**Marbach Pump Station Improvements (Volume I) &
Mission Road Service Center Drainage (Volume II) (RFCSP)
Solicitation Number: CO-00533
Job No(s): 20-6001/21-2501**

**ADDENDUM 6
September 27, 2023**

DRAWING NO.: **M-04**
SHEET NO.: 40 OF 193

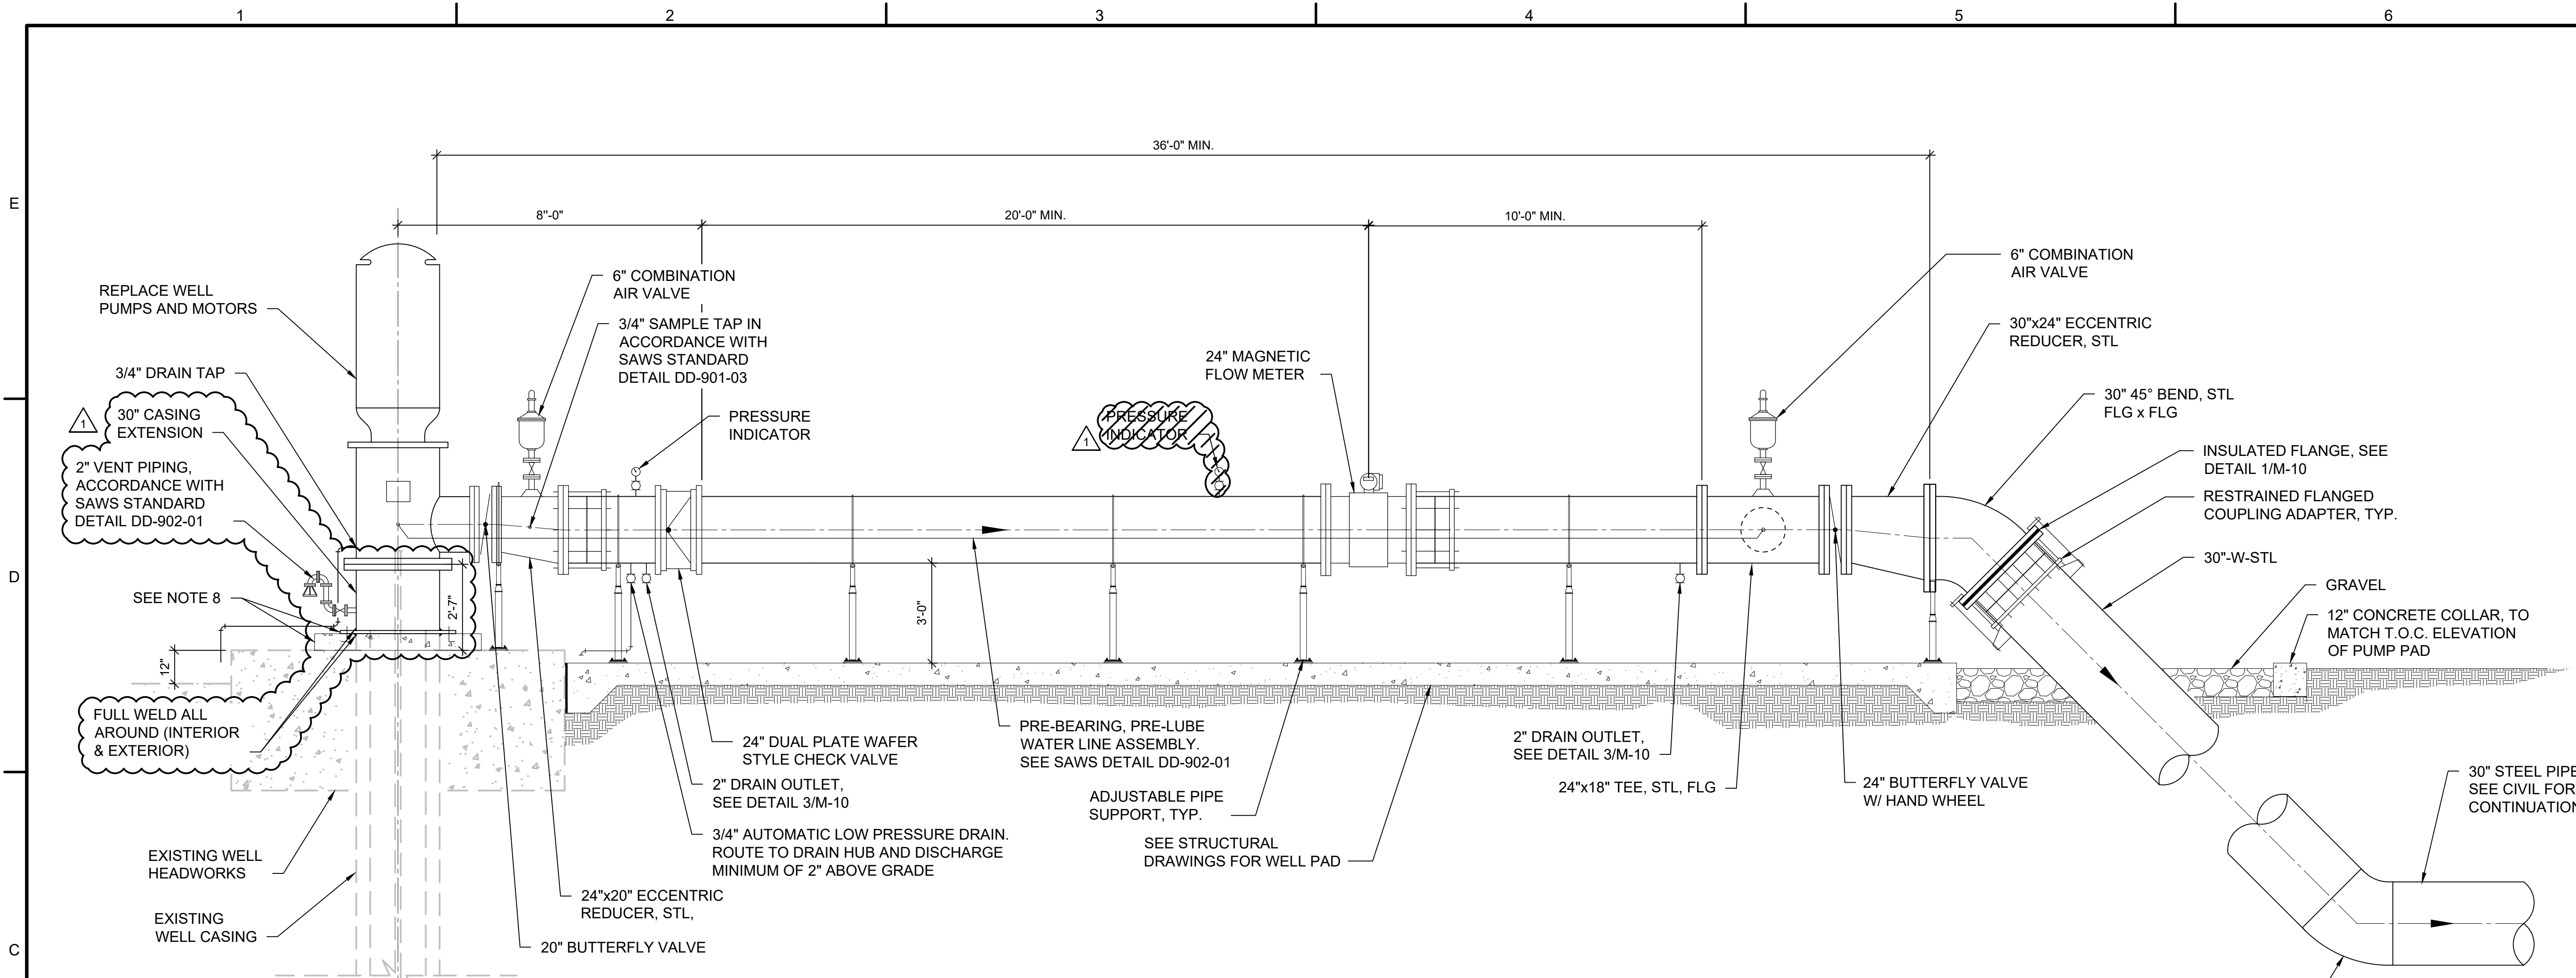
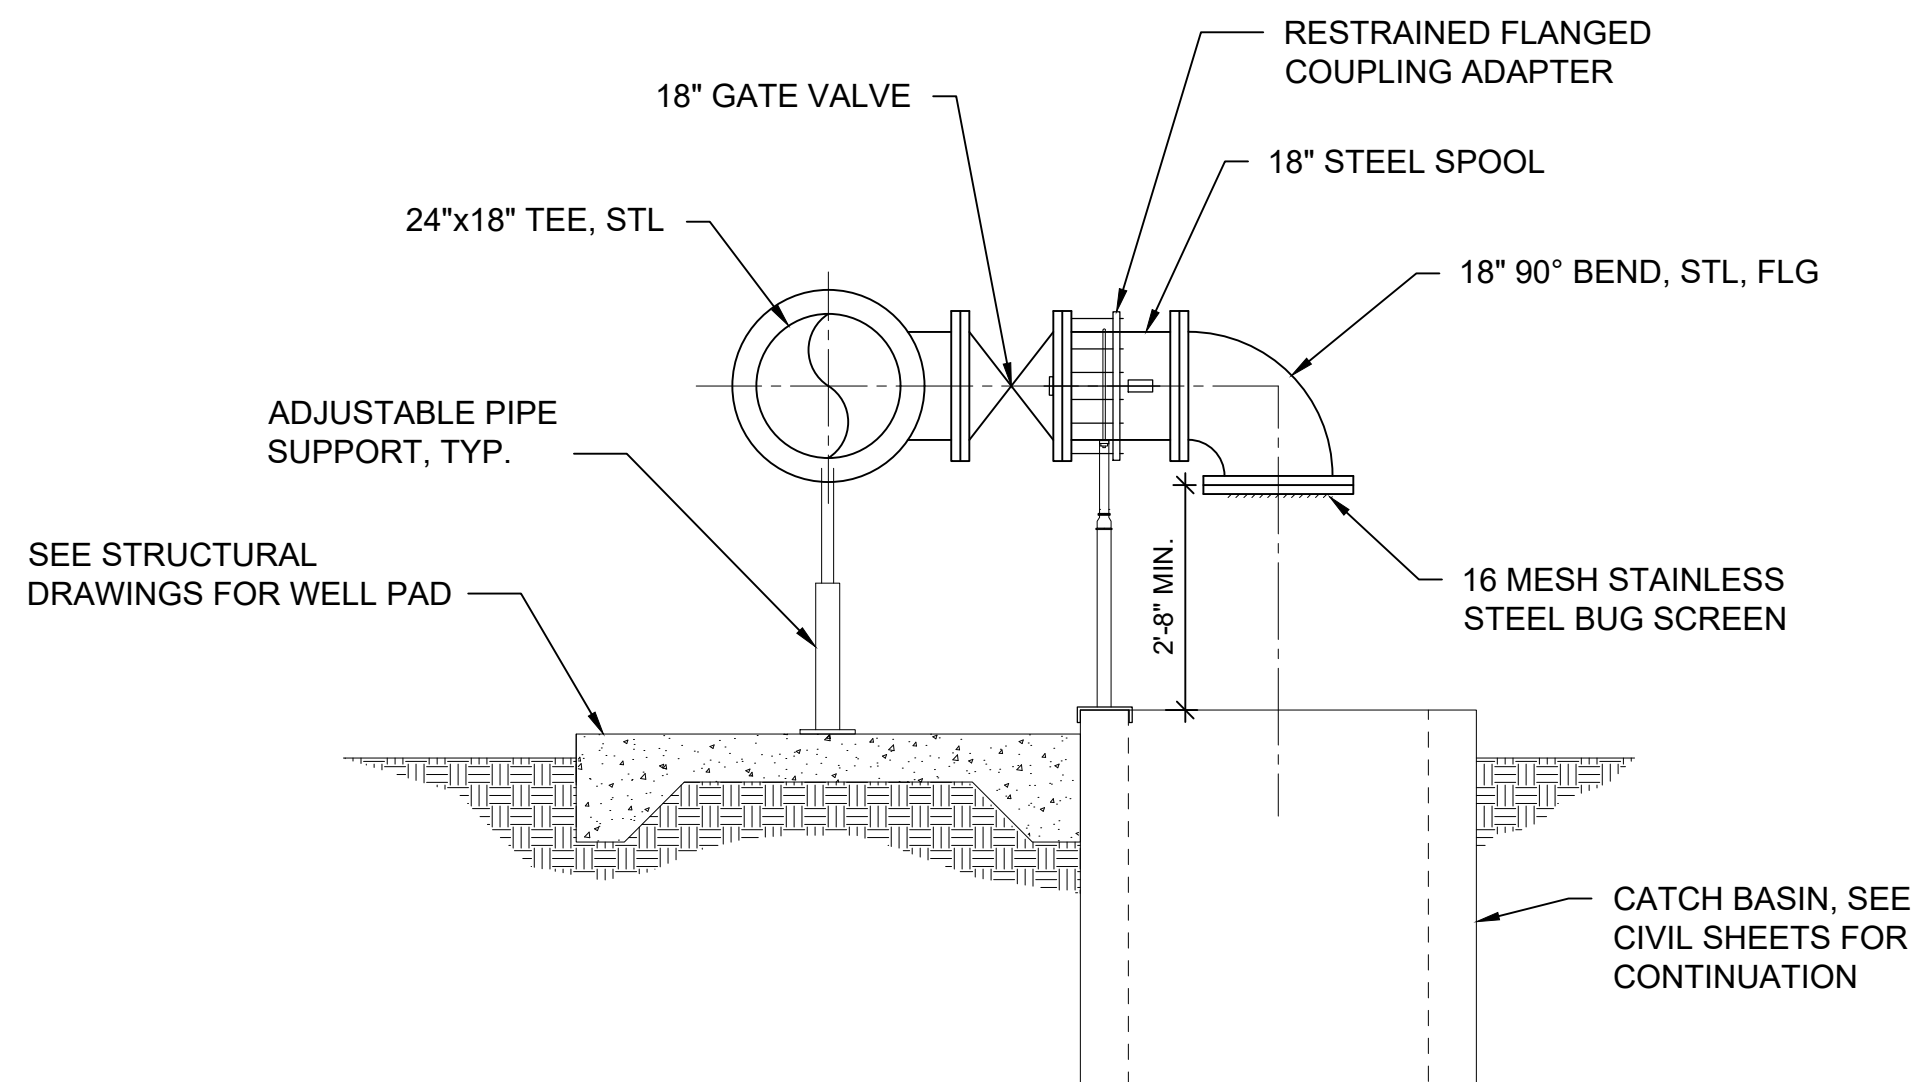
- 35. Question: M-04 – 20” spool piece as shown is not an acceptable design. New surface plate needs to be provided with well casing extension. Casing extension will be welded in the field to the existing 30” well casing after setting surface plate at proper elevation. Foundation will be formed around surface plate extension, and then grouted in place. Air vent would be connected to extension.**

- 78. Question: Drawing M-04 shows two pressure gauges on the Well Pump discharge lines and drawing I-04 only shows one gauge. Please clarify how many pressure gauges are to be provided for the Well Pump discharge lines.**

- 79. Question: Drawings M-04 call out for 4” vent piping in accordance with SAWS standard DD-902-01. SAWS detail DD-902-01 sheet 2 of 3 calls out for 2” vent piping for well casing sizes 16”-24”. The existing well casing diameter was not located in the specification and is not called out on the drawings. Please confirm the existing well casing diameter and if the vent pipe should be flanged as shown on the mechanical drawings or threaded as shown on the mentioned detail.**

Response: Plans will be revised as recommended. See Item No. 2 in the CHANGES TO THE PLANS section of this addendum.

Response: One pressure gauge is required on the Well Pump discharge line. Existing Sheet I-04 is correct, to reference one pressure gauge. PI location has been revised for Sheet M-04. See Item No.2 in the CHANGES TO THE PLANS section of this addendum.

Response: Existing Well Casing Diameter is 24”. Sheet M-04 has been revised to include 2” vent piping in accordance with SAWS standard DD-902-01. See item No. 2 in the CHANGES TO THE PLANS section in this Addendum.
